## Nordonia Hills City Schools – 2023 Summer Roofing

### Addendum #1

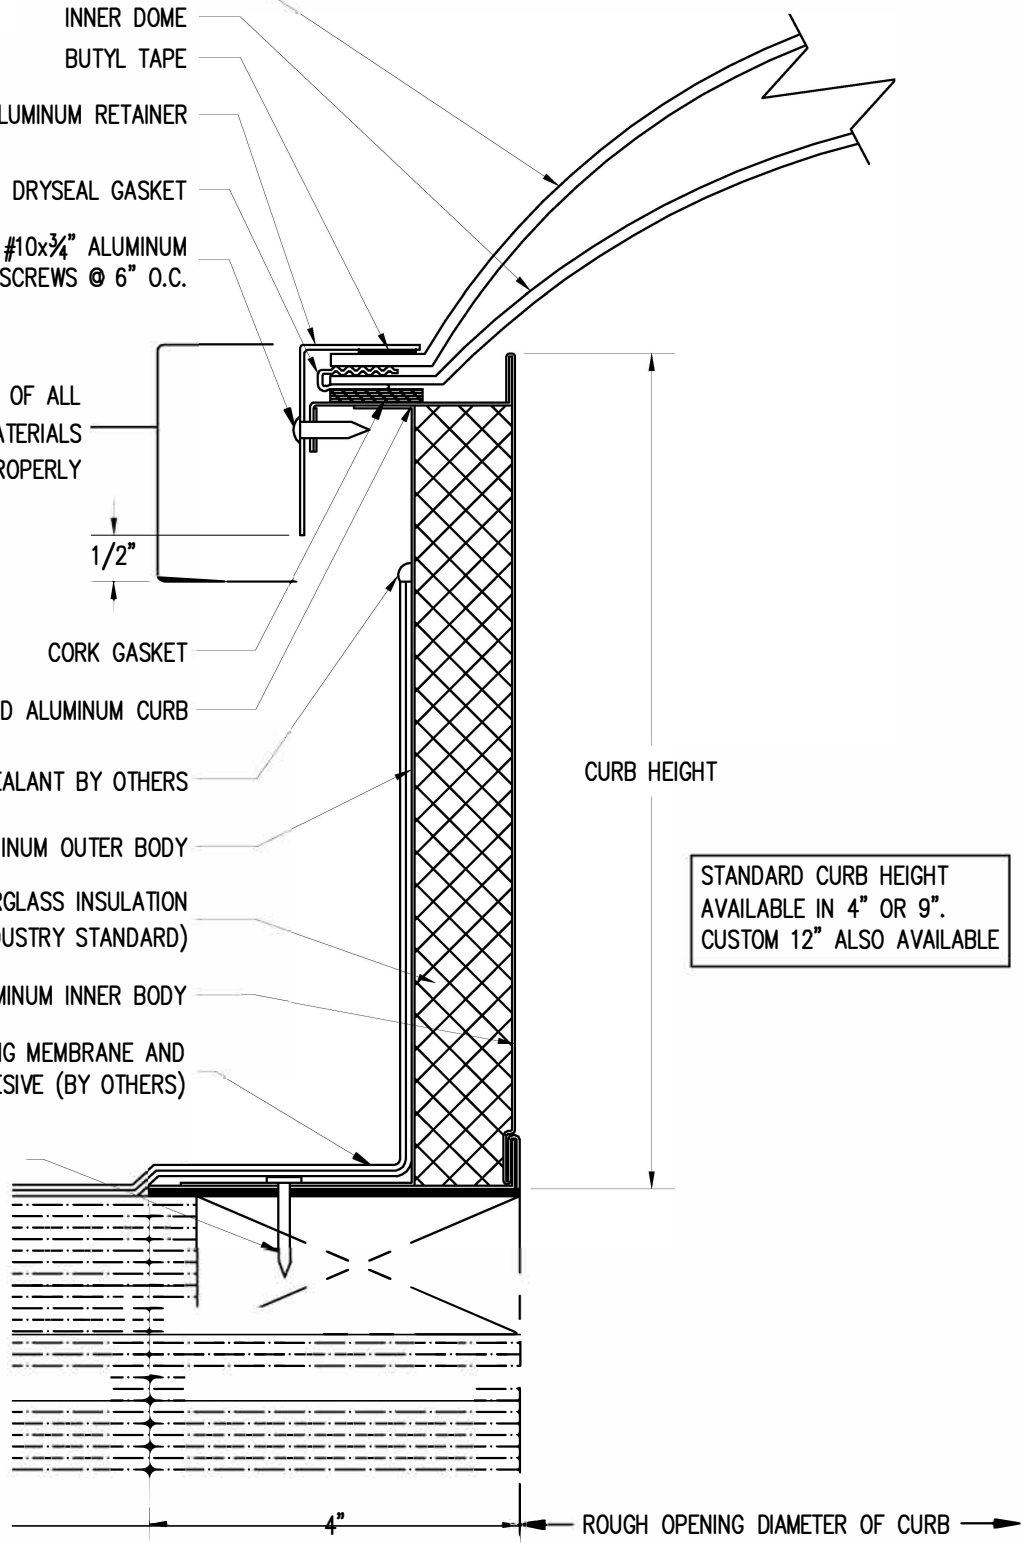
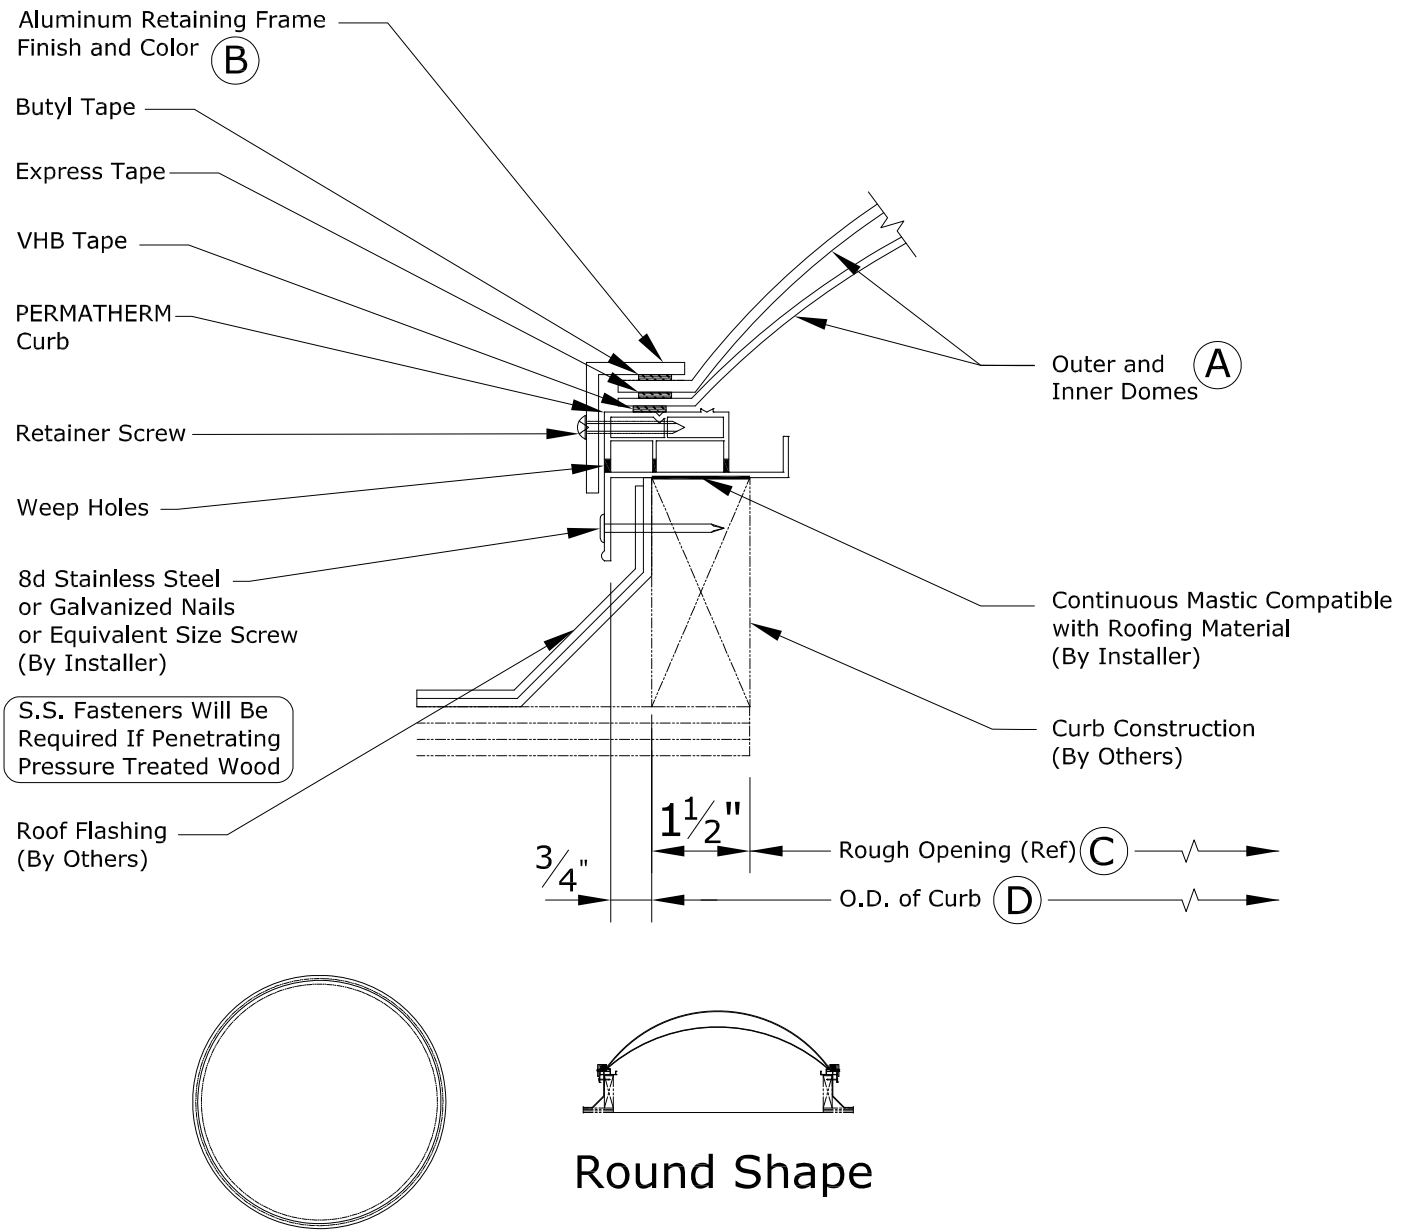
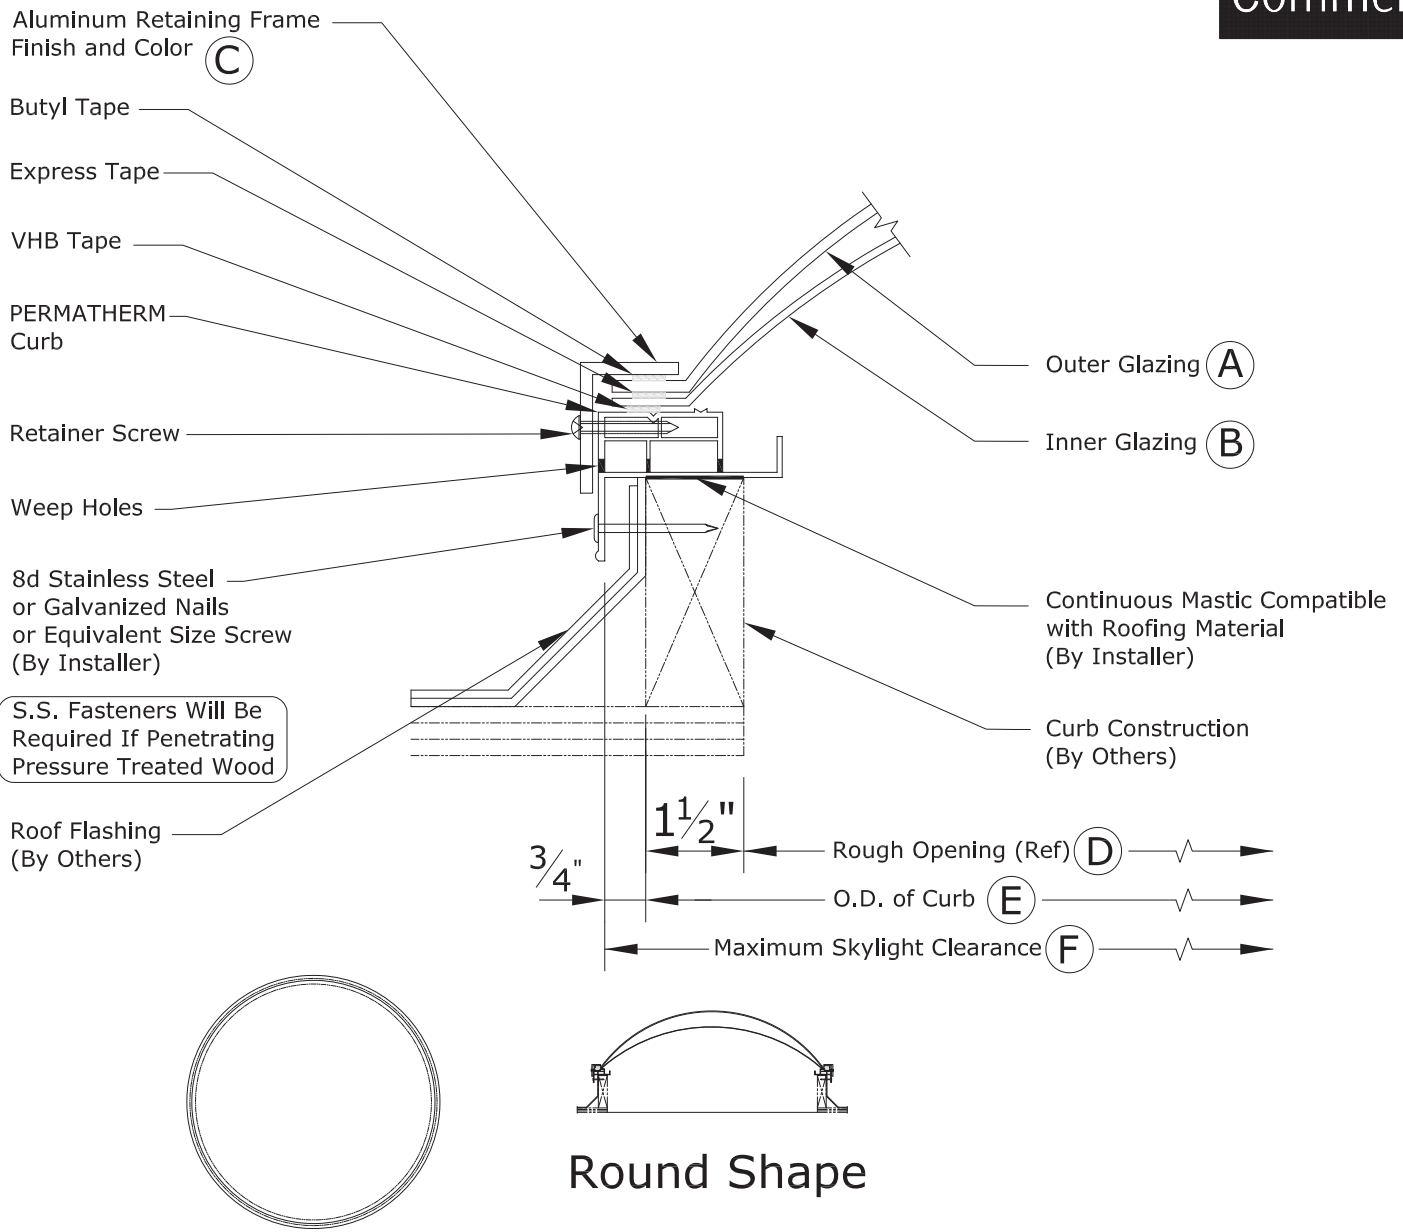
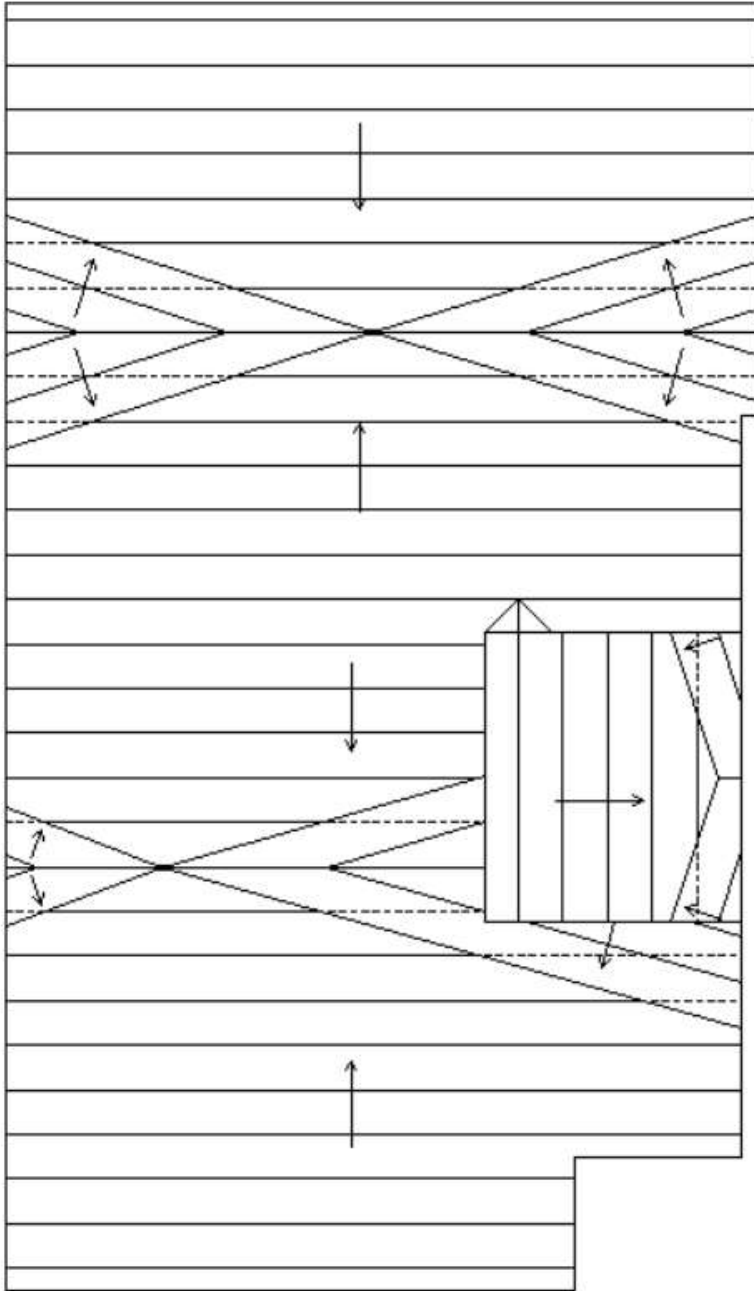
- 5.) **Northfield Elementary School, Section C** – the school district will raise the gas pipe if needed.
- 6.) **Rushwood Elementary** – Replace the dome only and reuse the curb. The sky light cut sheets are attached.

Nordonia Middle School -  
Sections J & K.

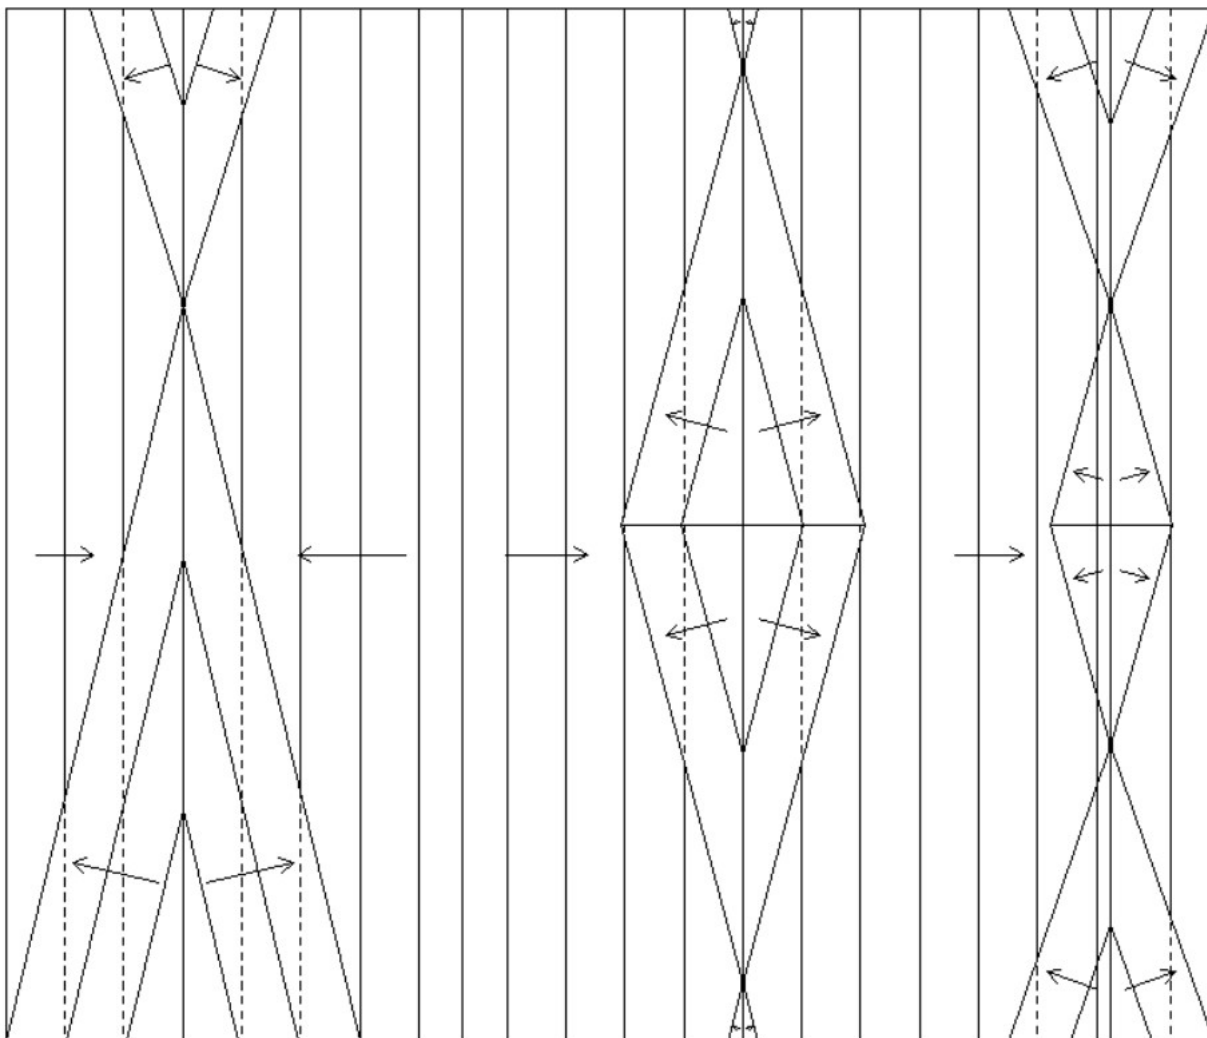
- The surface of the sloped roofs are coated with aluminizer. No flood and gravel is needed.
- 8.) **Nordonia Middle School Section J and K & Rushwood Elementary Section E** - tapered plans are attached. The contractor is responsible for all measurements. They have been provided by Willoughby Supply, John Bradley: (330) 802-2105. johbradley@srsicorp.com
